**MEMORANDUM TO:** Mayor and City Council  
Planning Commission

**DATE:** March 13, 2014

**SUBJECT:** Staff Analysis:  
SDP-3878-2013  
Washingtonian North  
Schematic Development Plan  
10000 Block of Washingtonian Boulevard

Parking Garage facing the Lifetime Fitness Building (Exhibit #24)

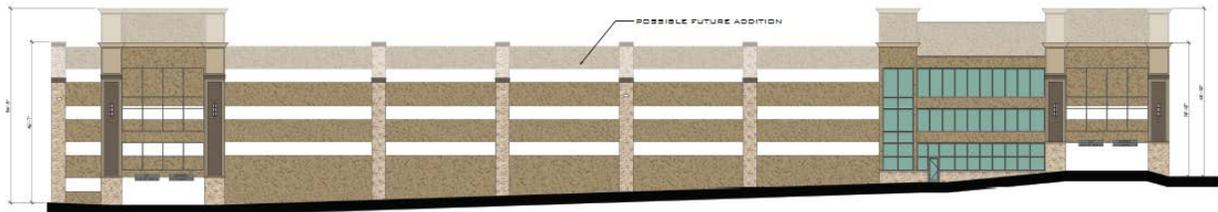
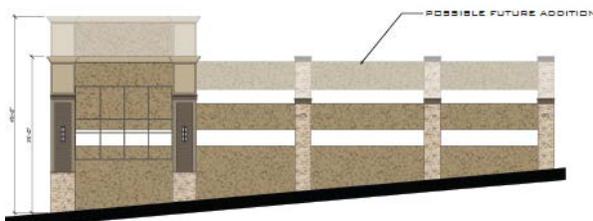
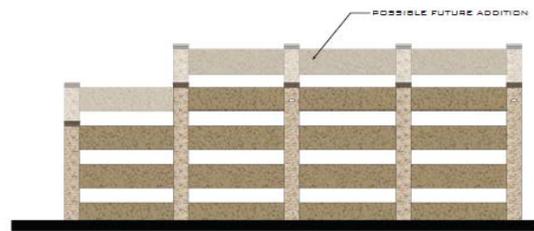
Staff would recommend the installation of a green screen or revised architectural elevations on the south and east elevations of the LifeTime Fitness garage shown in the boxes below. A condition related to the architectural elevations of the garage has been added.
